RIFLE TO SAN JUAN 345 - KV TRANSMISSION LINE AND ASSOCIATED FACILITIES

FINAL ENVIRONMENTAL IMPACT STATEMENT

MARCH 1984

USDA-REA-WAE-EIS (ADM) 84-1-F

Figure 2-3
(Figure 3-15)
**MONTEZUMA/LA PLATA COUNTY
LINE TO LONG HOLLOW
SUBSTATION ALTERNATIVE
CORRIDORS**

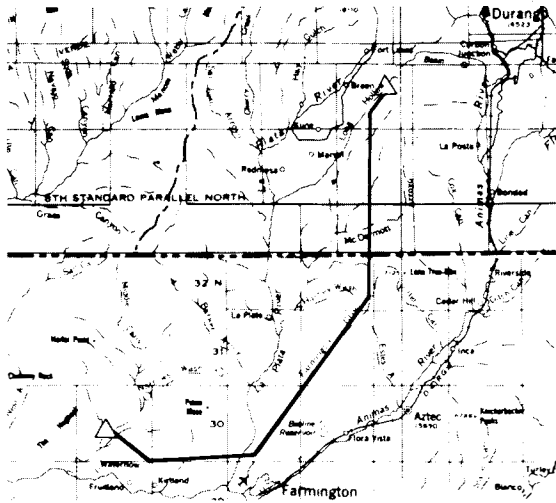
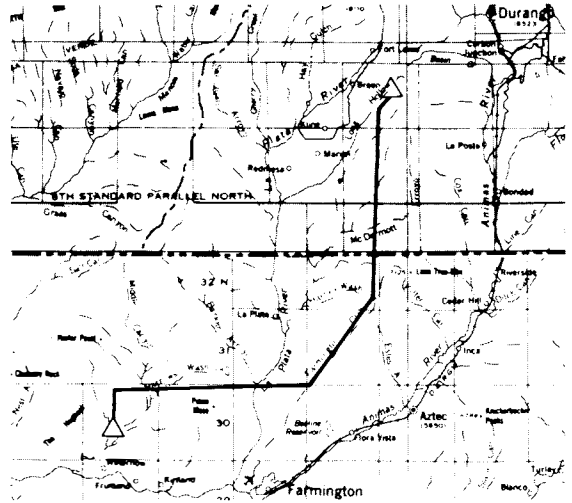
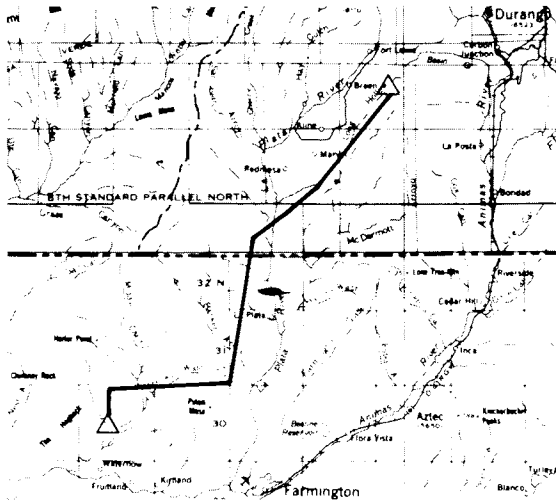
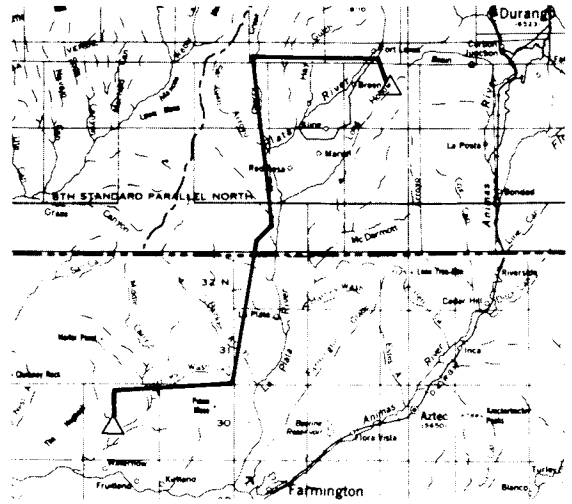
Was Figure 3-15 used to obtain miles and score for Table 3-10? If so, Table 3-10 needs redoing in the Final EIS. Figure 3-15 -- All alternatives have to be remapped and redone. Substation location on all is 3 to 6 miles too far North.

Figure 3-15 shows graphically apparent manipulation as far as alternative creation to obtain the preferred. Distance means expense and more impact so why is alternative c the only one that diagonals? All others have straight lines with basically 90 degree corners. To be truly alternatives, A, B and E should cut out 90 degree turns and diagonal also to make them competitive and comparable to obtain the best route.

Figure 3-15 was not used to obtain the miles and scores used in Table 3-10. The intent of Figure 3-15 was only to illustrate the basic differences between the alternatives under consideration between the Montezuma/LaPlata County Line and the proposed Long Hollow Substation. The substation was incorrectly located on the maps. Corrected Figures 3-15 and 3-16 are included in Section 2.2.3 of this FEIS.

Figure 4-29
SEGMENTS 31g, 31h, 32a,
32b, 32c

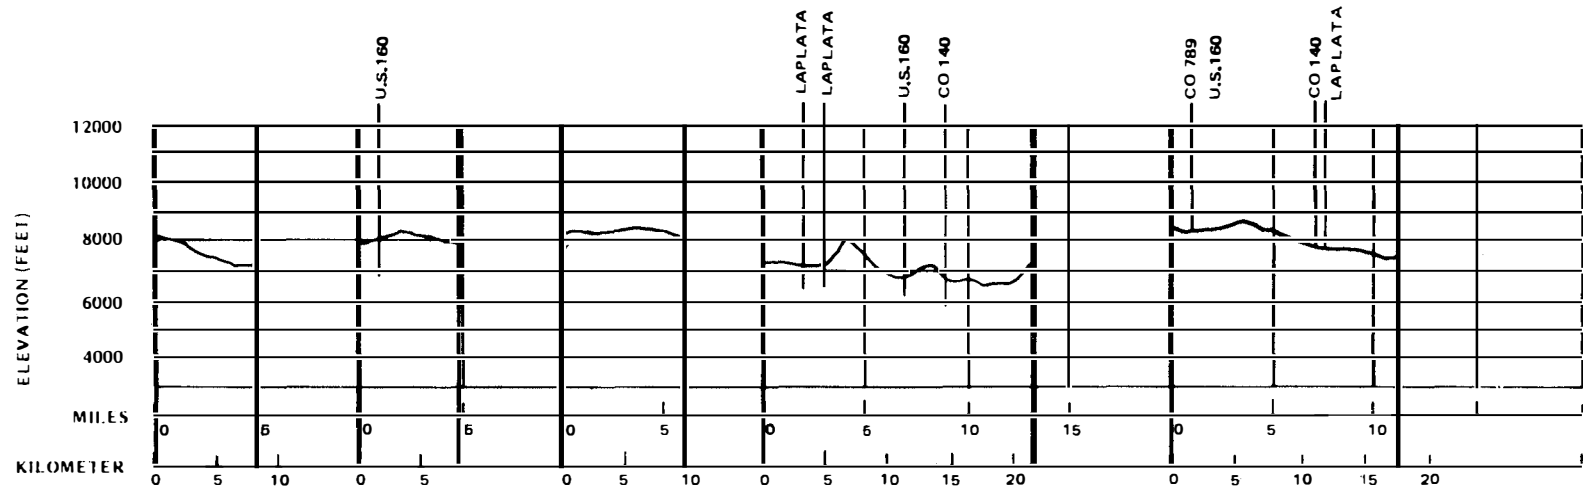
At no point does Segment 32a in reality go below 8,000 feet elevation as it does in Figure 4-29. The elevation scale for Segment 32C is off many places by several hundred feet -- correct these.

Land ownership listed for 32c Figure 4-29 are incorrect. 32c shows only 1/2 mile of contiguous P. This is impossible. Correct this using BLM ownership maps covering this segment. There is a mile of state land in this segment with several disconnected Public Tracts as well as private.

Agricultural areas, Figure 4-29. There are more nonirrigated than are shown in 32c.

Commercial forest with standing trees exists in Segment 32c. This is not shown in figure 4-29 and needs to be added. If potential commercial forest is used on private lands based on the U.S. Forest Service criteria for 32a, Figure 4-29, then most of Seg. 32c has commercial forest. Not to include it here would constitute discrimination against private owners and could constitute a civil rights violation.

A revised Figure 4-29 is included in Section 2.2.4 of this FEIS (Figure 2-5). Elevations have been corrected on the figure.

The land ownership information in Figure 4-29 (Figure 2-5 of this FEIS) has been modified to include the state and public land noted in the comment.

The source used to compile the agricultural land information for Figure 4-29 does not substantiate the comment. According to the source, nonirrigated cropland occurs along Corridor Segment 32c in Sections 14 and 15, T34N, R11W.

Figure 1-1
PROPOSED PROJECT
AND EXISTING FACILITIES

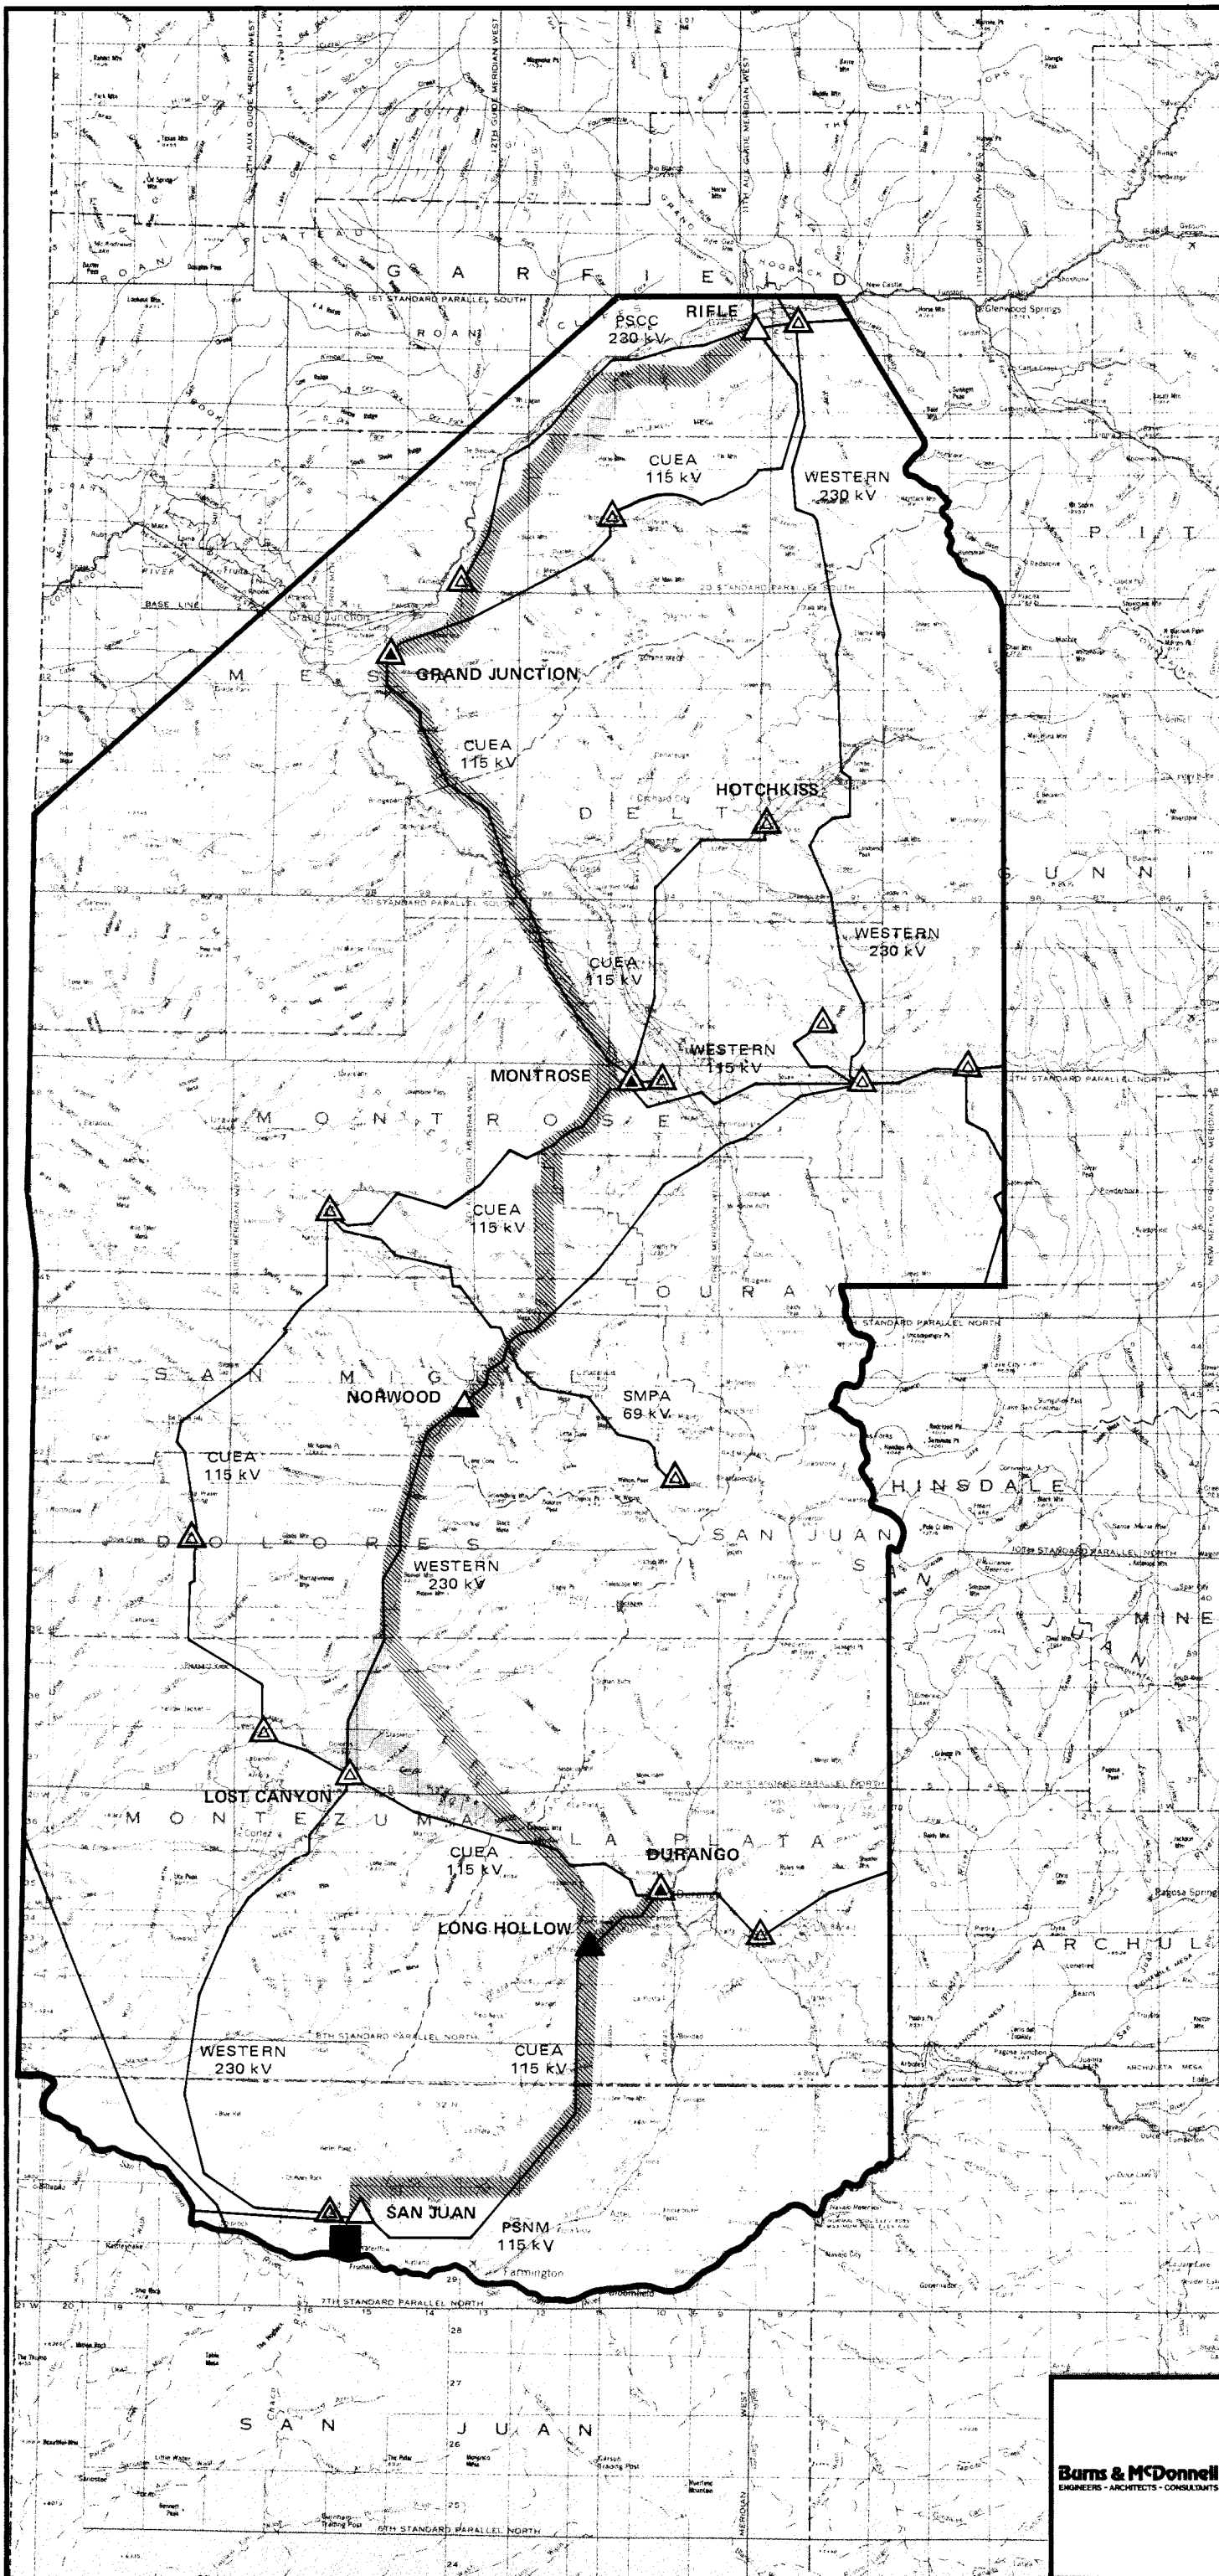
Page 1-4, first paragraph is misleading when it states that the proposed line would parallel Western's 230 kV line to the Montezuma, La Plata County line. In fact, it does for a distance but it is proposed to leave it as shown in figure 1-1 of the SDEIS.

- P. 1-4, sixth line from top of page - change sentence to read "The line would continue southerly approximately 91 km (57 mi) paralleling Western's 230 kV transmission line approximately 48 km (30 miles) south of the San Miguel/Dolores County line then extending to the Montezuma/La Plata County line."
